STATE OF CALIFORNIA - DEPARTMENT OF TRANSPORTATION

SAS SUPERSTRUCTURE - CONDUIT AND CABLE TRAY PLAN

SK-RFI3244R00-E97
Adil M. 4/3/13

SK-RFI3244K00-E264F-1
R. GARCIA 4/2/13

SK-RFI3244R00-E264F-2

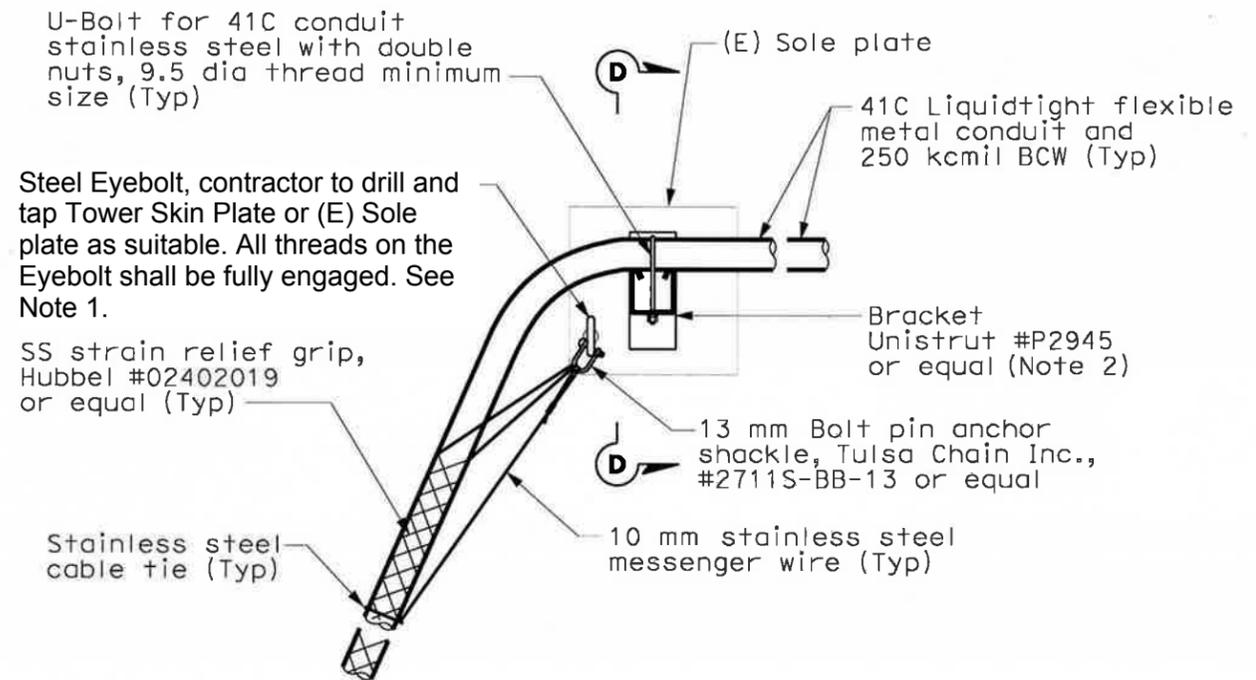
1. Eyebolt location to suit field condition.
2. Bracket may be rotated 180 degree if U-bolt is not available with longer thread length. Conduit shall be placed on top of channel strut.
